**Preliminary review of
Recommendations for Enhancing Reactor Safety in the 21st Century: The Near-Term Task Force Review of Insights from the Fukushima Dai-ichi Accident,
U.S. Nuclear Regulatory Commission, July 12, 2011¹**

Arjun Makhijani, Ph.D.²
Prepared for Friends of the Earth
July 19, 2011

Figure 1: Map of estimated first year radiation dose, estimated by the U.S. Department of Energy.⁵

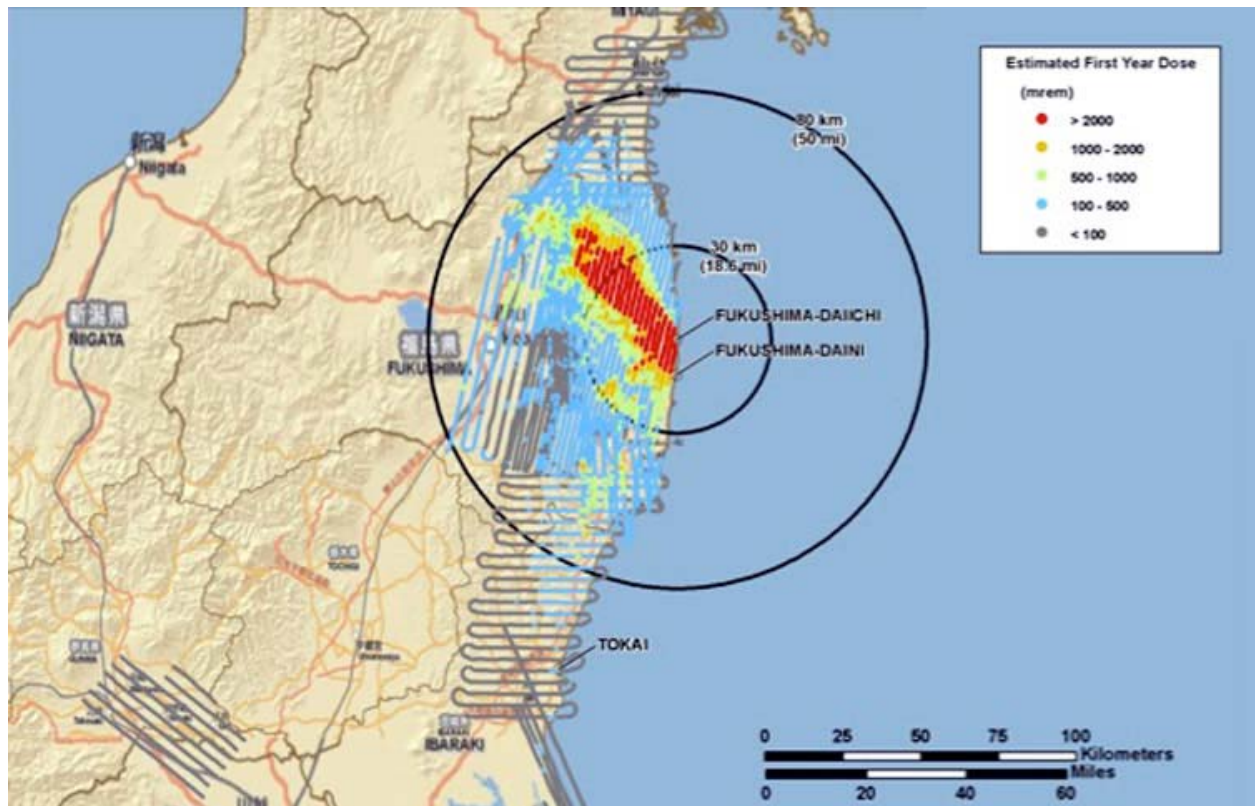
Figure 1 shows the radiation doses that the U.S. Department of Energy estimates will be experienced by the public around Fukushima in the first year after the accident from external

radiation sources and inhalation of re-suspended particles if they stayed outdoors all the time. Building shielding factors, which would reduce dose, and internal radiation dose due to ingestion or incorporation of radioactivity via cuts and wounds, which would increase dose, are not taken into account. Ingestion of soil is especially important for children.⁴ Long-term risks will grow since there will be further radiation doses in future years and also from radioactivity deposited after the DOE surveys. Therefore, as a first approximation, the map may be taken as an order of magnitude indication of the risks faced by the public, especially beyond the 20-kilometer evacuation zone, where there were no restrictions on activities in the initial months.

The red-shaded area represents a dose of more than 2,000 millirem (2 rem). Using the cancer risk coefficient published by the U.S. EPA,⁶ the fatal cancer risk at the minimum dose of 2 rem would be about 1 in 1,150.
